BID FOR THE CONSTRUCTION OF
HARBATA GOVERNMENTAL HOSPITAL

Addendum No 1

Answers to Bidders Clarifications

E004

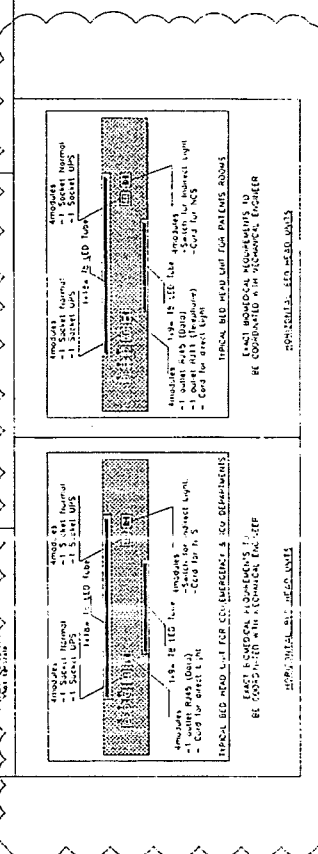
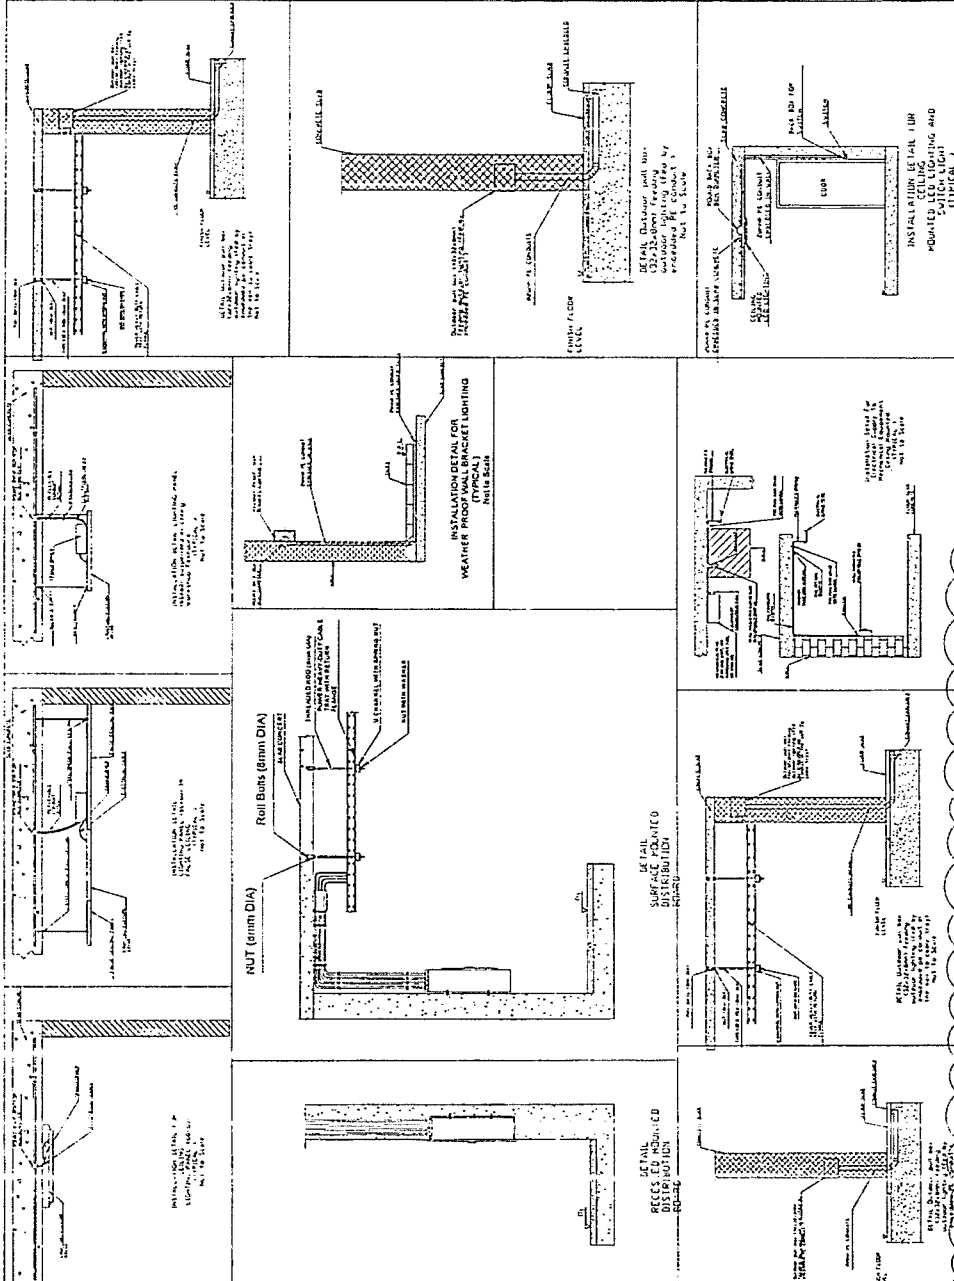
2.1	Electrical specifications reference a BMS (Section 16786). Kindly confirm whether a BMS is included in the project scope.	Not included in this phase.
2.2	We require detailed specifications for the bed head unit, which are currently missing.	Refer to Attachment-3 (Draw. E-004 Revision 1)
